PRODUCT / PROCESS CHANGE NOTIFICATION
PCN-000785

For business continuity purposes, Semtech will start using qualified alternate sources for assembly and test for the above-mentioned parts.

Qualification of Greatek Taiwan as a second source Assembly manufacturer for LORA and ISM products

SEMTECH Package Outline on SX1236IMLTRT/ SX1277IMLTRT/SX1279IMLTRT (Carsem and Greatek)

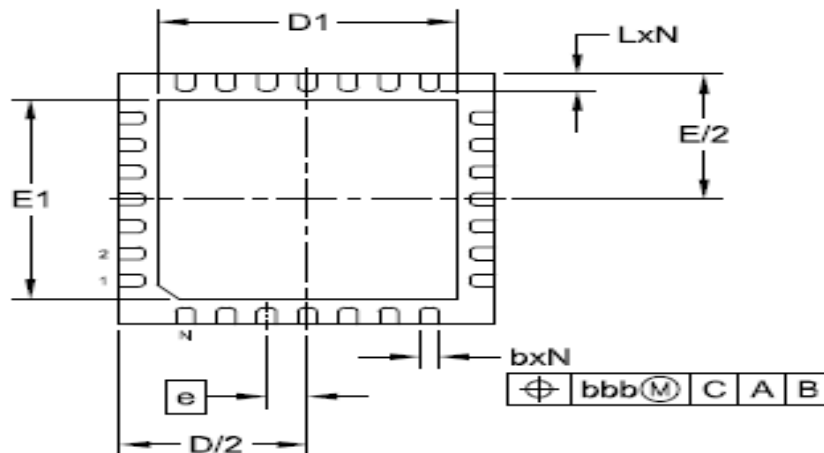
**No Change in
Package Outline.**

Assembly Process Flow (Carsem vs. Greatek)

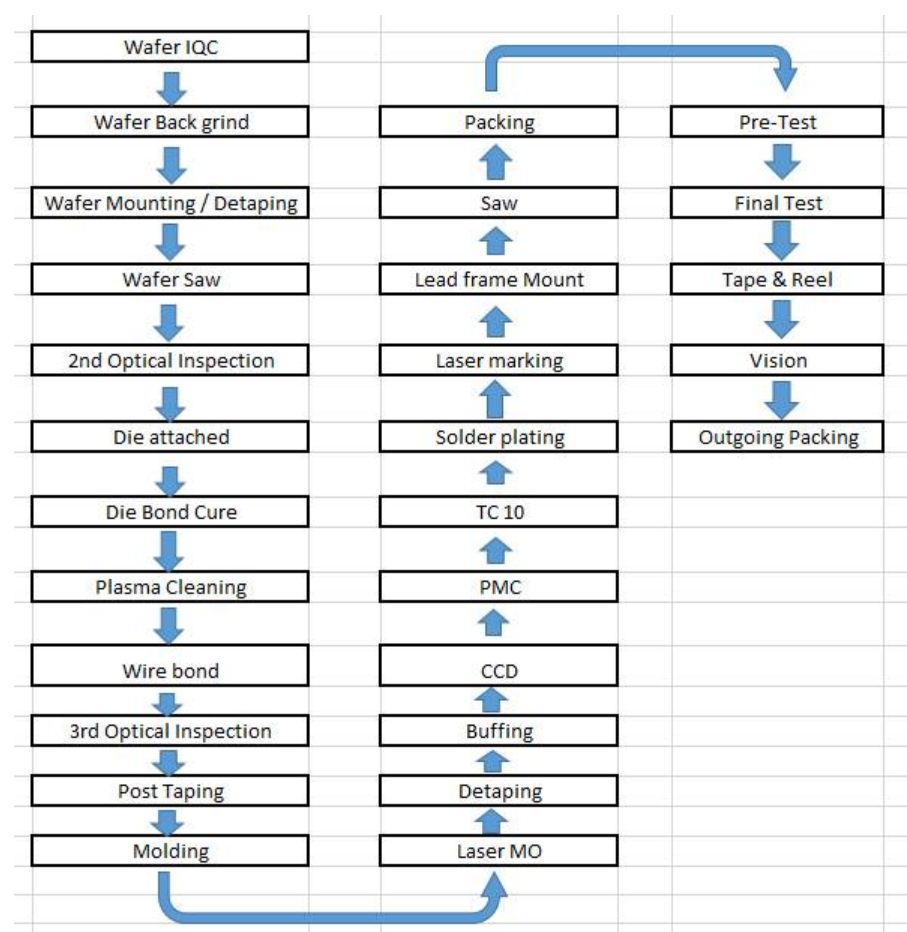
- No major Change in manufacturing Flow
- 1X IR reflow process step is applied in the assembly flow for both Carsem and Greatek.

Carrier tape 6x6 comparison (Carsem Vs Greatek)

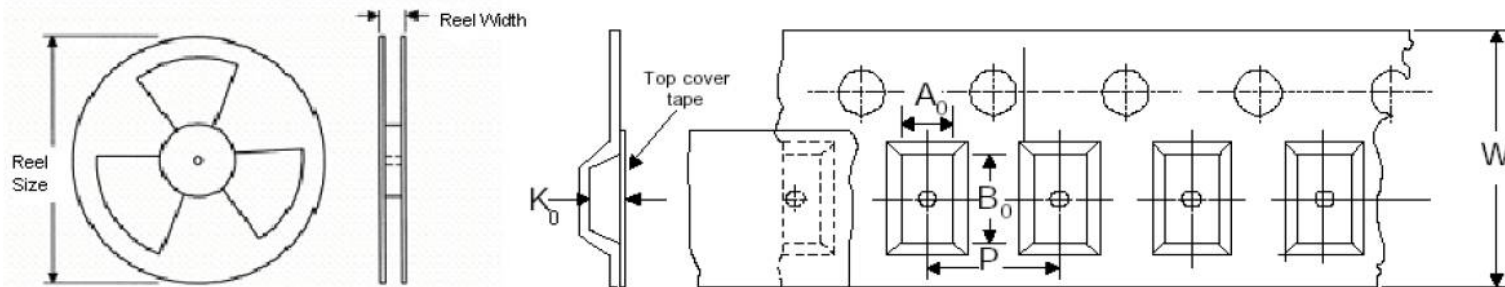
Carrier tape suppliers are different but critical dimensions are identical.
